SPRING BRANCH INDEPENDENT SCHOOL DISTRICT

ADDENDUM NO. 1

PROJECT: Agricultural Center Systems Upgrades Project No. Y02P87, SBISD
Proposal No. 9005P

ADDENDUM NO. 01

5/A1.02: REMOVE EXISTING ELECTRICAL

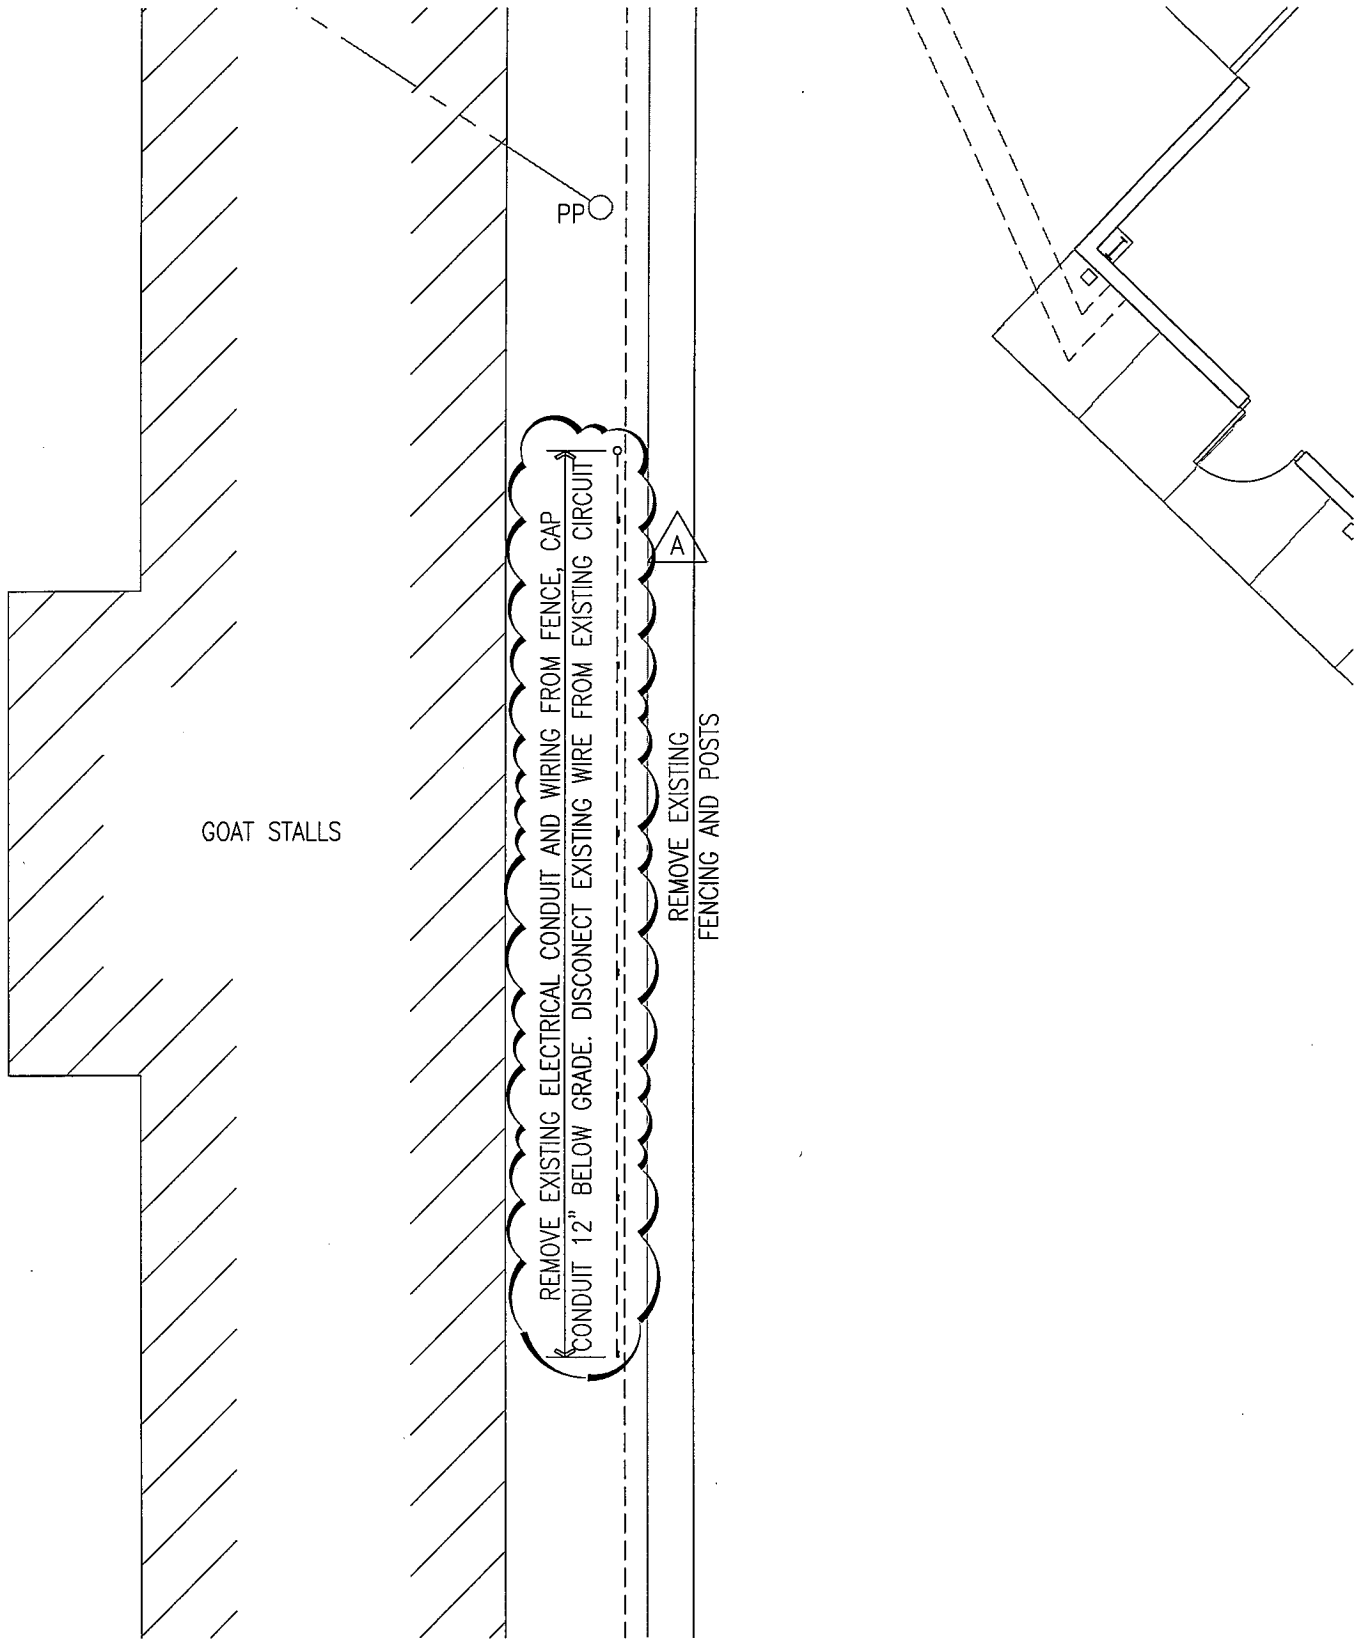
09. A1.02 – Enlarged Demolition Plan
 - a. In detail 5/A1.02 add the note as per the attached sketch ADD1.1.
10. A1.03 – Enlarged Demolition Plan
 - a. In detail 6/A1.03 add the note: “SECURITY CAMERA TO BE REMOVED AND REINSTALLED BY OWNER. CONTRACTOR TO COORDINATE REMOVAL WITH THE OWNER” to locations inside the barn and above the east and west large barn doors (a total of 2 cameras will be removed and reinstalled by the owner during construction.)

A2.01: NEW CONDUIT FOR PHONE LINE

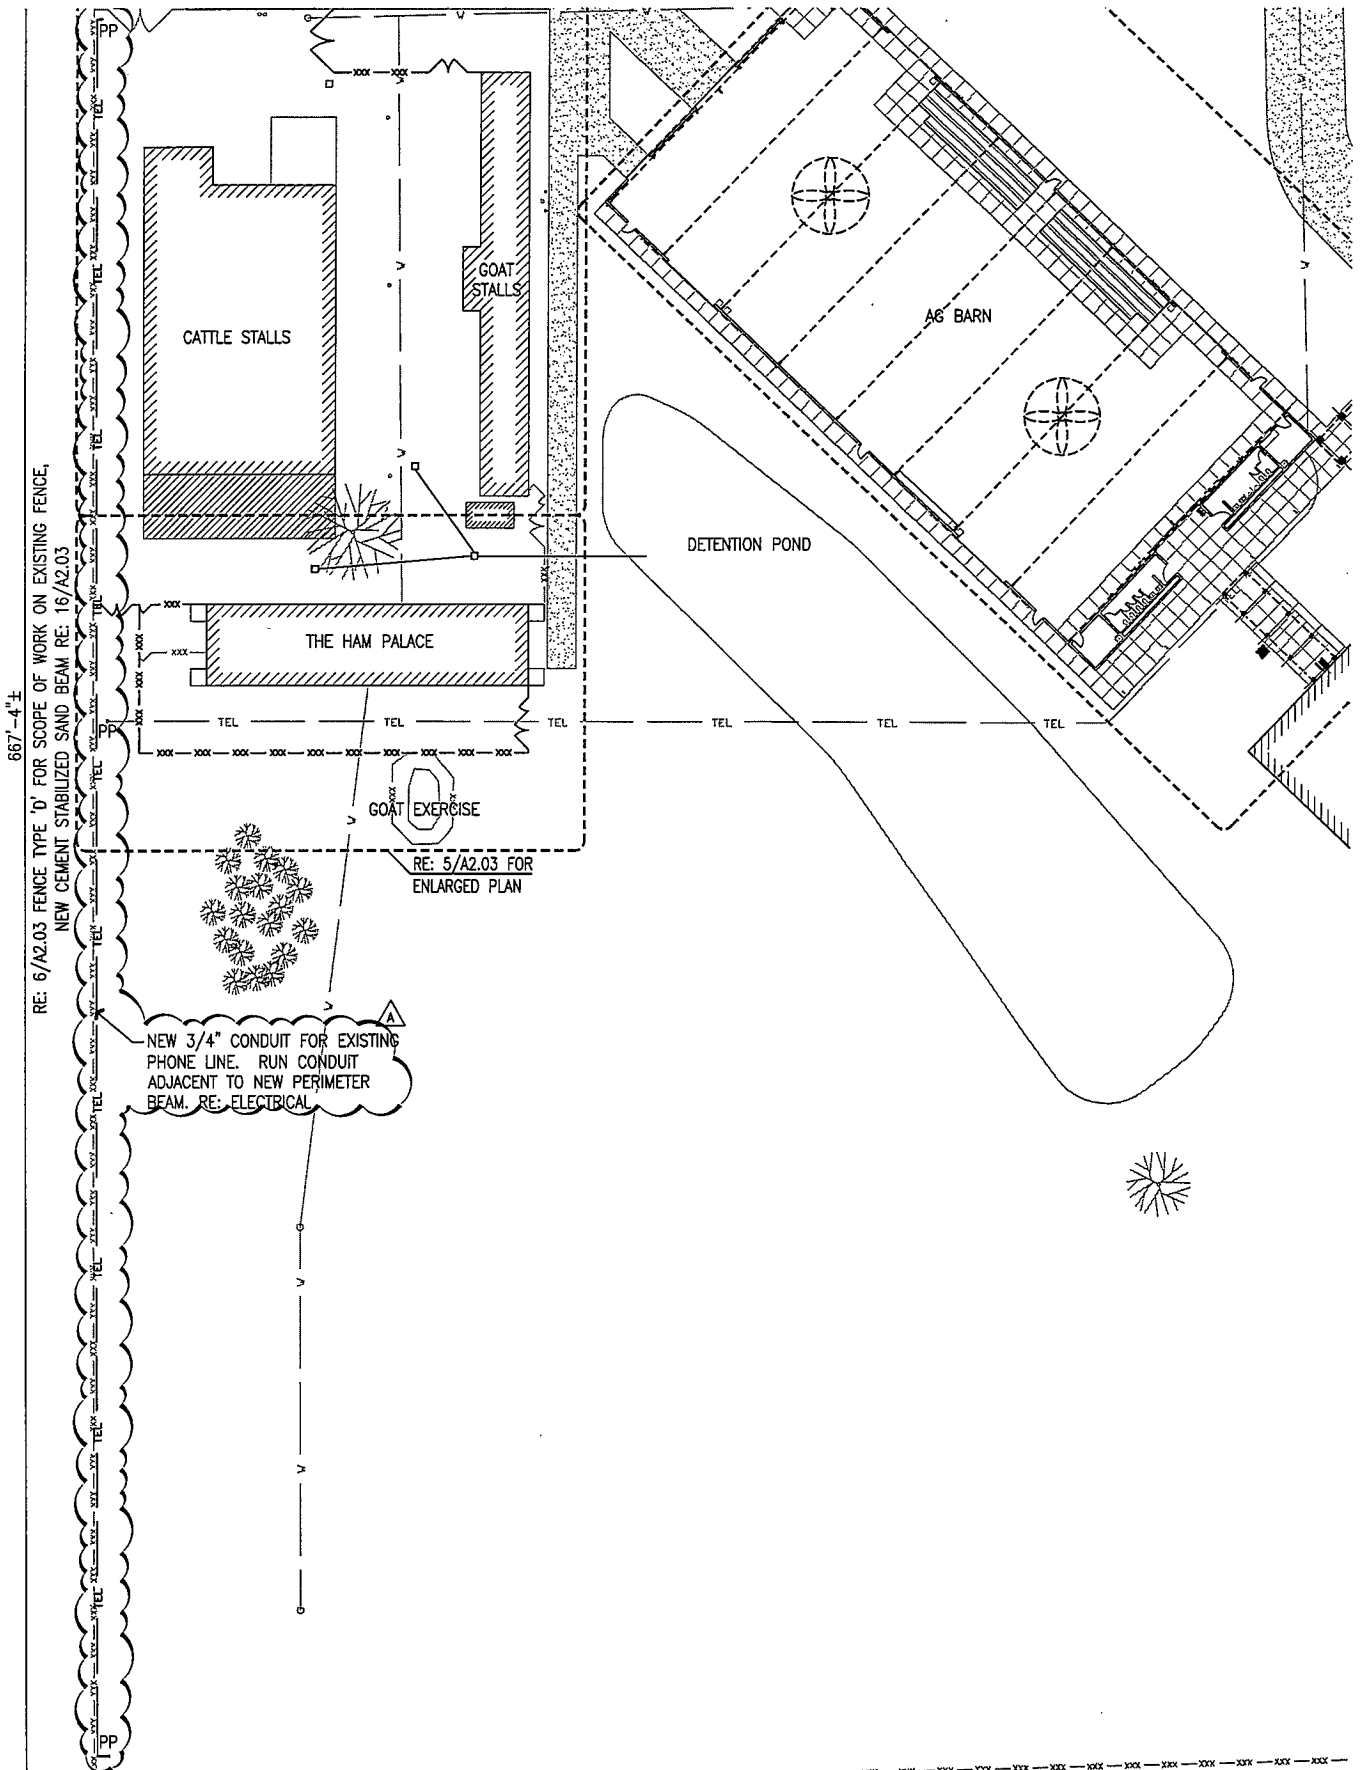
11. A2.01 – Site Plan
 - a. Add the note along the west property line as per the attached sketch ADD1.2.
 - b. Modify the note “REGRADE EXISTING ROCK DRIVEWAY TO ENSURE ALL POTHOLES ARE REMOVED AND TO ENSURE PROPER DRAINAGE. REROCK DRIVEWAY AFTER REGRADING” to read “REROCK ALL EXISTING ROCK DRIVEWAY TO ENSURE ALL POTHOLES ARE REMOVED AND TO ENSURE PROPER DRAINAGE.”

667-4"±
 RE: 6/A2.03 FENCE TYPE 'D' FOR SCOPE OF WORK ON EXISTING FENCE,
 NEW CEMENT STABILIZED SAND BEAM RE: 16/A2.03

NEW 3/4" CONDUIT FOR EXISTING
 PHONE LINE. RUN CONDUIT
 ADJACENT TO NEW PERIMETER
 BEAM. RE: ELECTRICAL

30/A2.02: STORM SEWER OUTFALL STRUCTURE

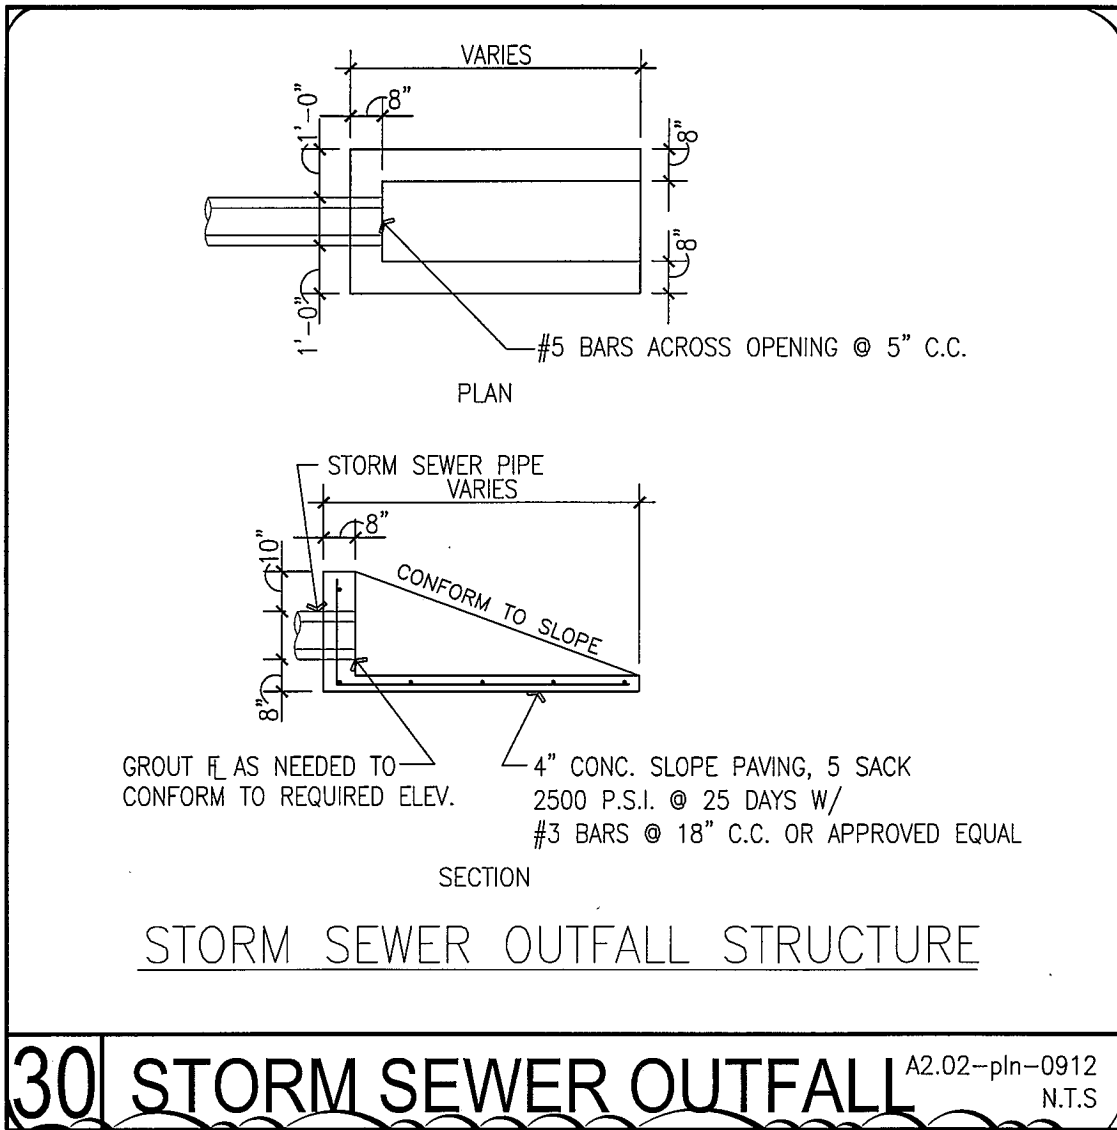
- c. Modify detail 24/A2.02 as per the attached sketch ADD1.3.
 - d. Add detail 30/A2.02 as per the attached sketch ADD1.4
13. A2.03 – Enlarged Site Plan

16/A2.03: MOVE BEAM TO INSIDE OF FENCE LINE

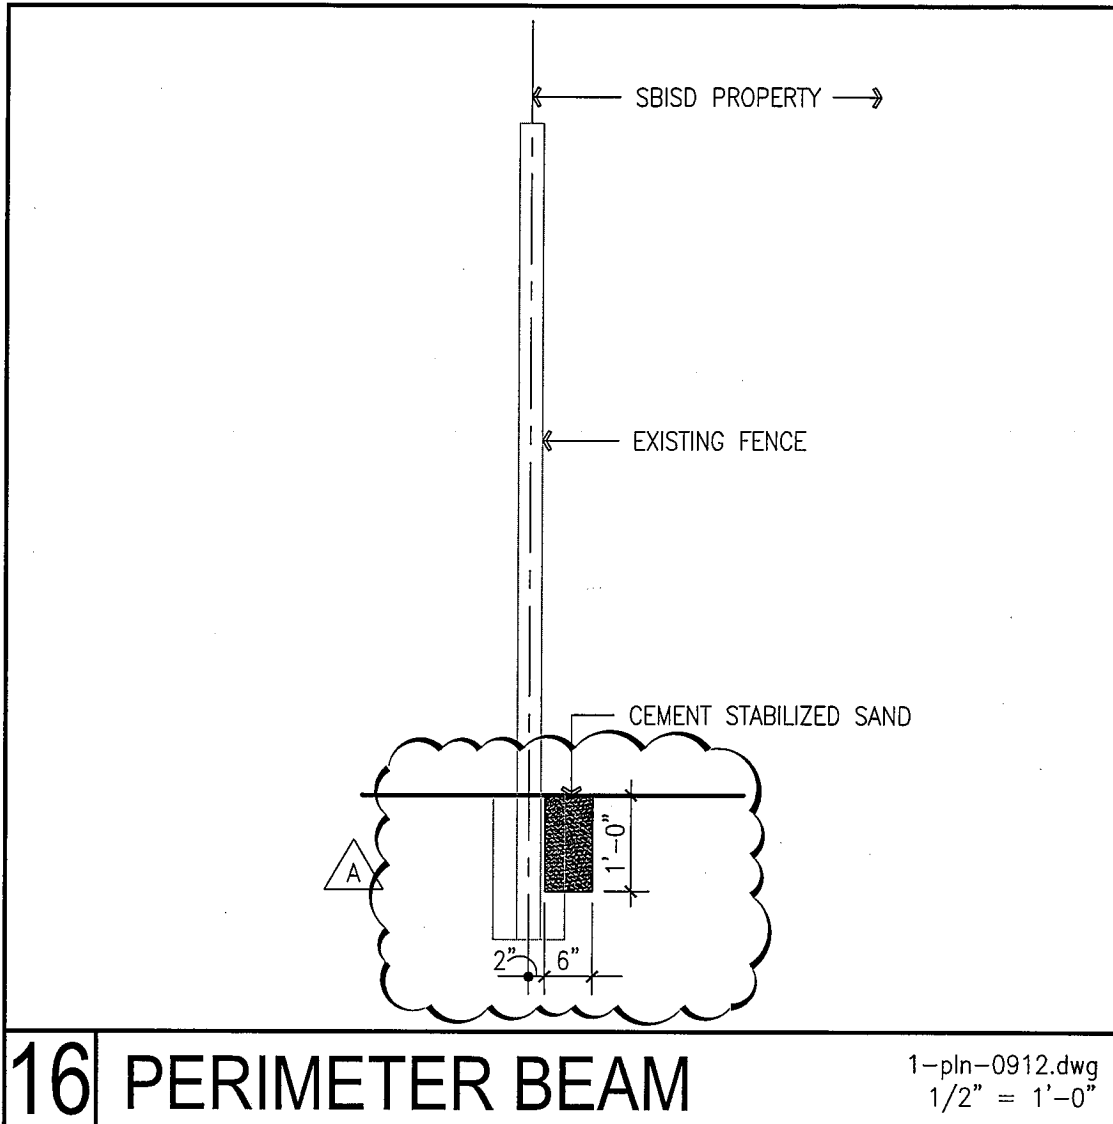
- a. In detail 16/A2.03 add the note as per the attached sketch ADD1.5.
 - b. In detail 24/A2.03 add the dimensions as per the attached sketch ADD1.6.
 - c. In detail 24/A2.03 replace the note “NEW CONCRETE DRIVEWAY, RE: 24/A2.02 FOR PAVING SPECS” with the note “NEW CONCRETE DRIVEWAY, RE: 24/A2.02 FOR PAVING SPECS. CONCRETE DRIVEWAY SHALL HAVE THE SAME FINISH FLOOR ELEVATION AS THE ROCK DRIVEWAY AFTER BEING REROCKED.”

NEW CONDUIT FOR PHONE LINE

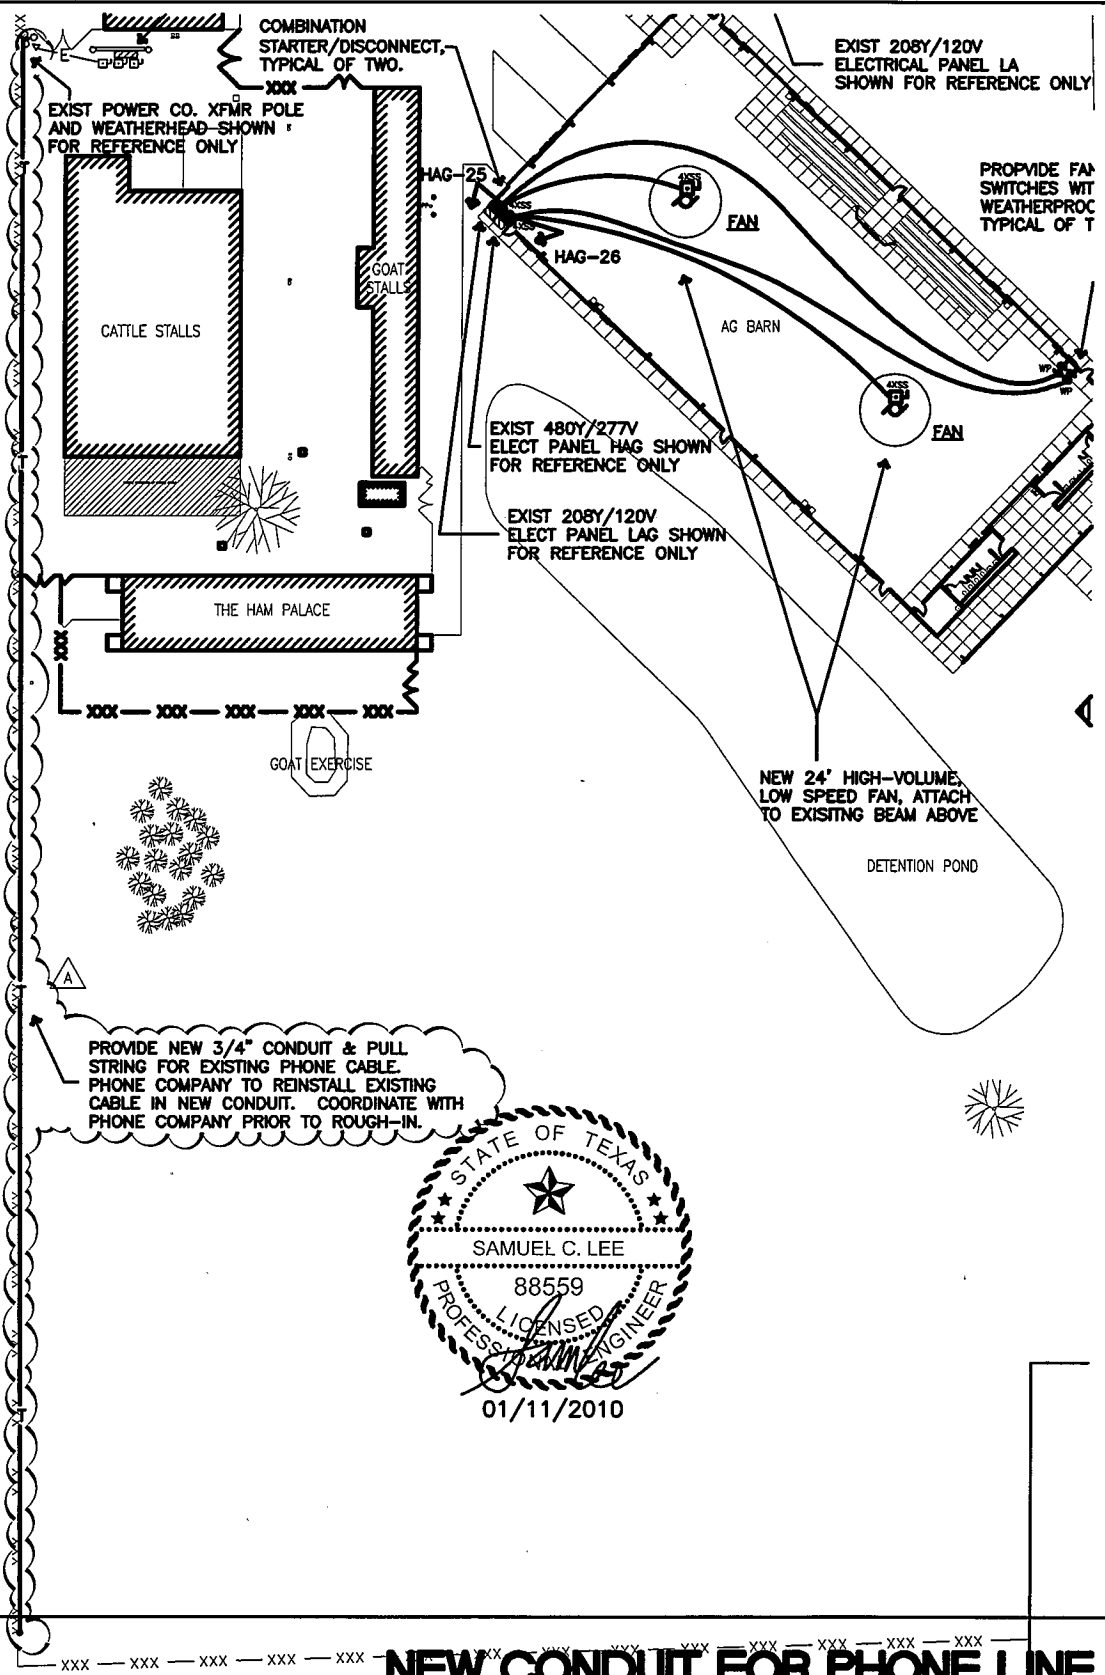
16. E1.01 – Electrical Site Plan:

- a. Add the note to the west property line as per detail ADD1-SKE-1.

PROVIDE NEW 3/4" CONDUIT & PULL STRING FOR EXISTING PHONE CABLE. PHONE COMPANY TO REINSTALL EXISTING CABLE IN NEW CONDUIT. COORDINATE WITH PHONE COMPANY PRIOR TO ROUGH-IN.
